CORRIGENDUM 1

Figure 2 – Flow charts test sequence to be applied when performing the type test (Figure 2a) and routine test (Figure 2b)

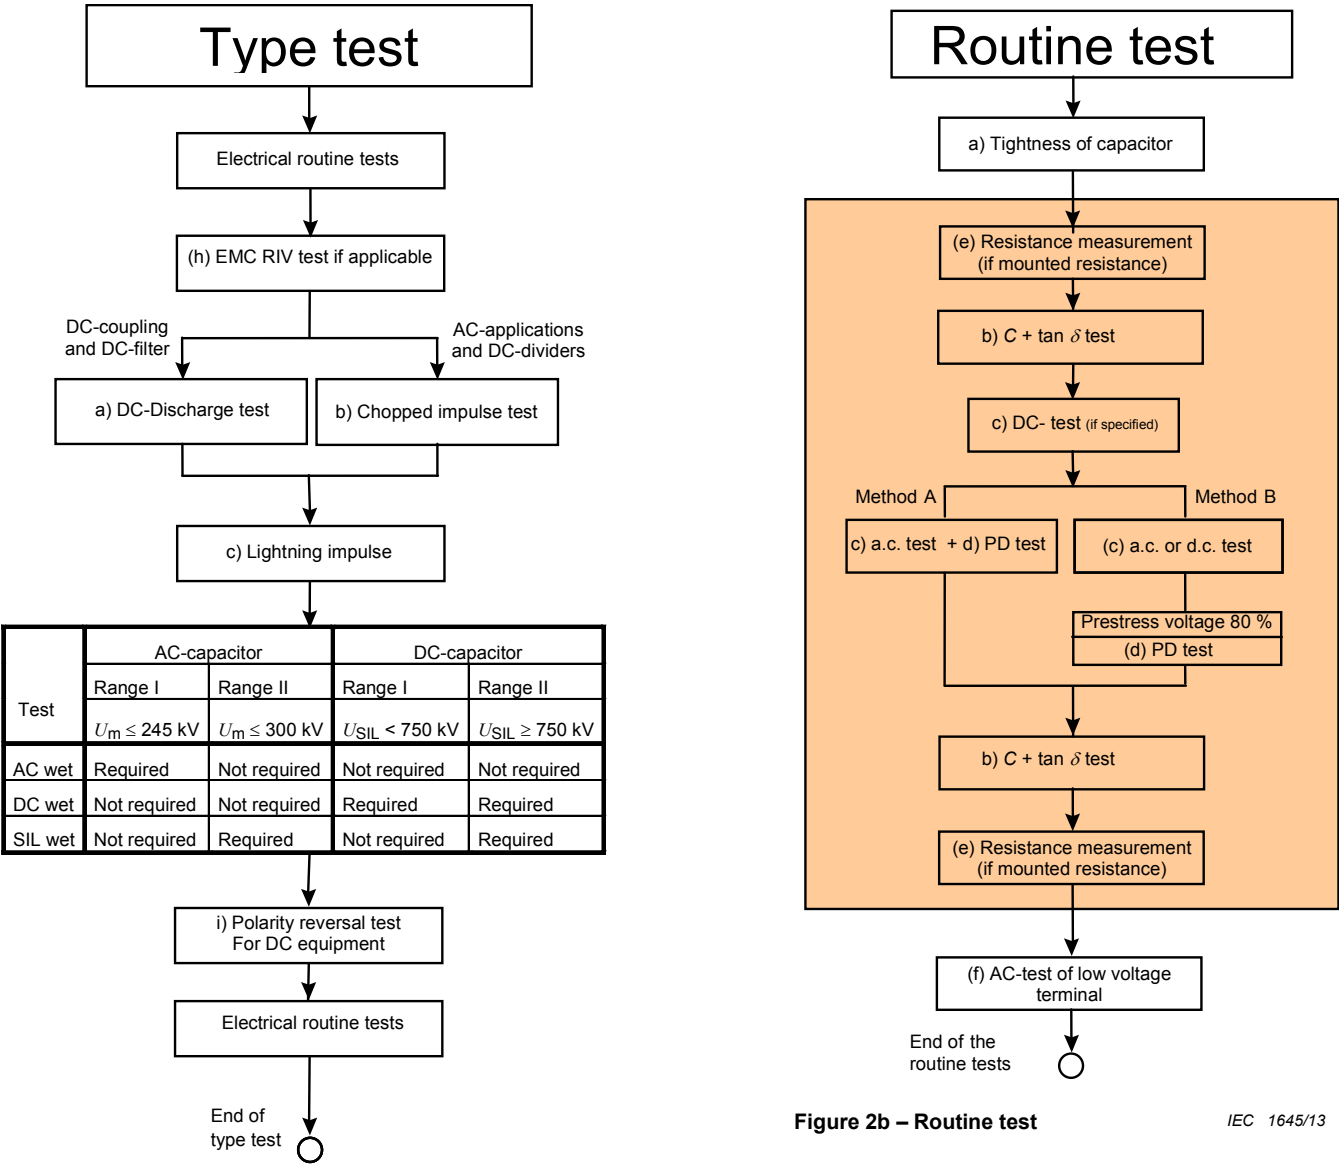
Replace the existing Figure 2 with the following new figure:
